# Mayor & Council of Berlin

**Town of Berlin  
Planning Commission  
February 11, 2026 - 5:30 PM  
Berlin Town Hall – Council Chambers**

**TO:** Planning Commission

**SUBJECT:** 513 S. Main St. – Final Site Plan Approval

# **PURNELL CROSSING - NORTH & SOUTH REVISED P.U.D. SITE PLAN**

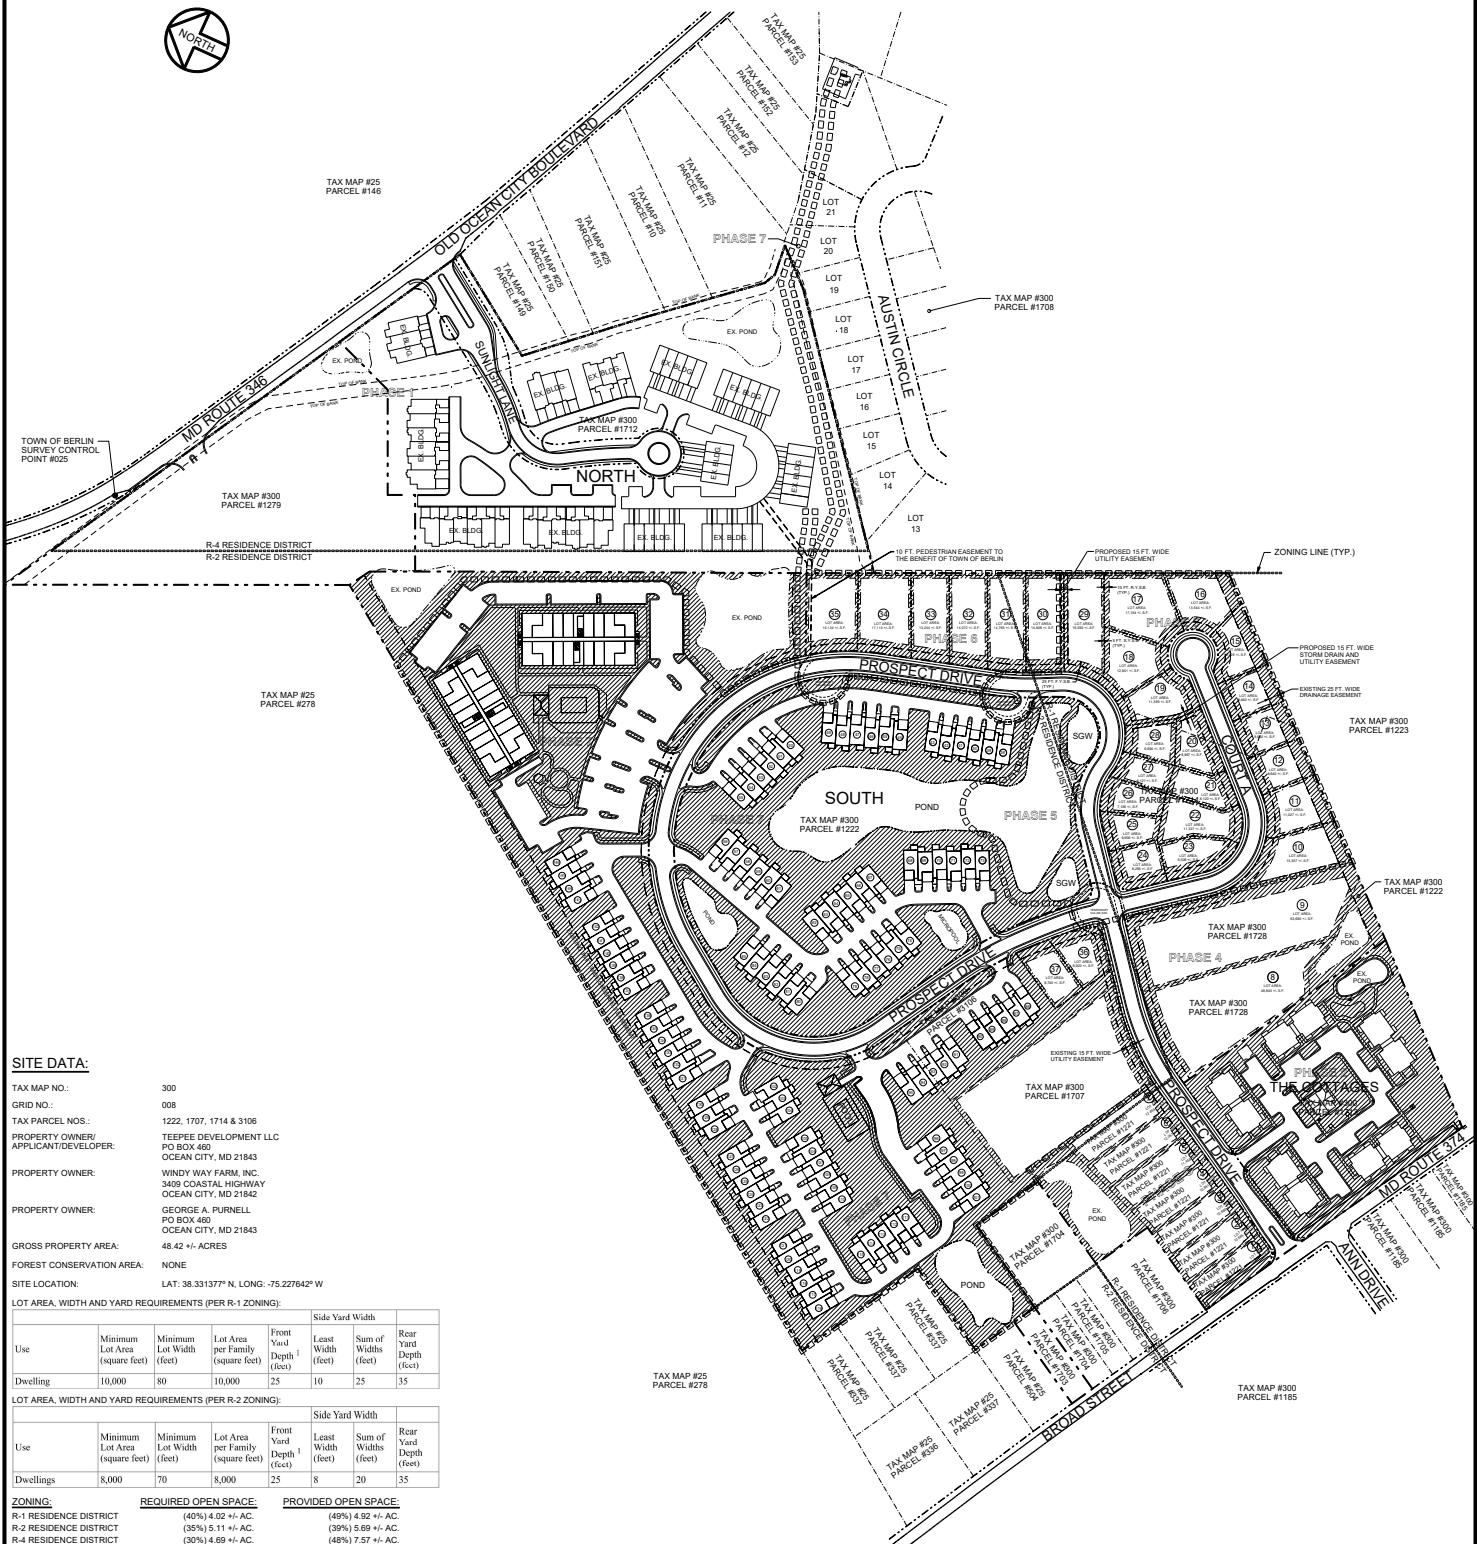
The Draft Revised Purnell Crossing PUD Master Plan seeks to modify the Phase 5 and portions of Phase 6 to increase the number of single-family homes from fifteen (15) in the 2019 Purnell Crossing Master Plan to thirty-six (36) single-family homes within the area Applicant's described Phases 5 and 6. The increase in the number of single-family lots from 15 to 26 appears to be accomplished in the Draft Revised Purnell Crossing PUD Master Plan by reducing the side and rear setbacks as well as the lot open space beyond the minimums allowed under the Town Code and the open space requirements, which beyond what is permitted under Town Code 108-703.

The details of the side and rear setbacks are not included on the Draft Revised Purnell Crossing PUD Master Plan, but it appears that the Applicant is seeking approval of lot configurations with lots with side-yard setbacks of 5 feet and rear yards of 10 feet (the minimum allowable rear yard in all residential districts is 35 feet).

The original PUD Master Plan (**Attachment 7**) as all single family lots to comply with the bulk standards as applicable for the R-1 zoning district. In the Draft Revised Purnell Crossing PUD Master Plan, it appears that the Applicant is seeking approval of lot configurations using a mixture of the standards from the R-1, R-2 and R-4 zoning districts with compliance with the standards from no single zoning district with some of the proposed 26 lots within Phase 5 and 6 with underlying zoning of R-1 and small portion underlying zoning of R-2 less than 7000 sf and lot widths just over 50 feet

The Draft Revised Purnell Crossing PUD Master Plan contains calculations based upon net square footage of open space, rather than gross square footage of open space. The Applicant declined to revise the calculations to gross, rather than net, that was requested by Staff, making it impossible for Staff to determine if the Draft Revised Purnell Crossing PUD Master Plan meets the Town Code § 108-717 requirements.

Based upon the information submitted by the applicant, staff feels that the Draft Revised Master Plan as submitted is incomplete, and that the said plan should be revised to incorporate the necessary information to demonstrate compliance with the code and applicable standards as well as meeting the intent of the PUD as approved in the original Master Plan in 2005 before approval. The Minor Subdivision and Boundary Line Adjustment associated with the proposed Phase 5 does not conform with approved Revised Master Plan. As such, any approval of the said Minor Subdivision and Boundary Line Adjustment should be conditioned upon approval of a Revised Master Plan to ensure conformity with any requirements for approval for the PUD Master Plan and to ensure any future subdivisions for the single-family homes comply with zoning and other Town Code requirements.

## LIGHTING PLAN

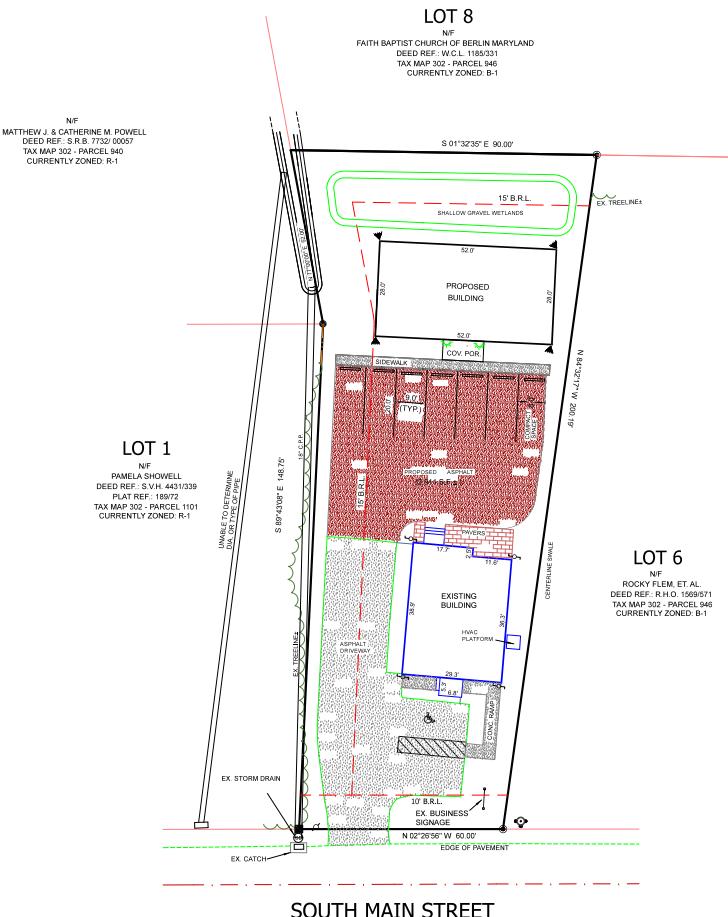
The project was initially reviewed by the Planning Commission in June 2024 at the concept stage. At that time, the Commission appeared supportive of the overall project concept. The applicant returned to the Planning Commission in October 2025, at which point Commission members requested that the applicant provide a landscaping plan and a lighting plan for further review.

The applicant is now returning to the Planning Commission having provided both an updated landscaping plan and an updated lighting plan addressing the Commission's prior comments. In addition, the project has received Final Stormwater Approval and has been reviewed by the Fire Marshal.

- The applicant has submitted a landscaping plan and a lighting plan in response to Planning Commission comments from October 2025.
- The project has received Final Stormwater Approval.
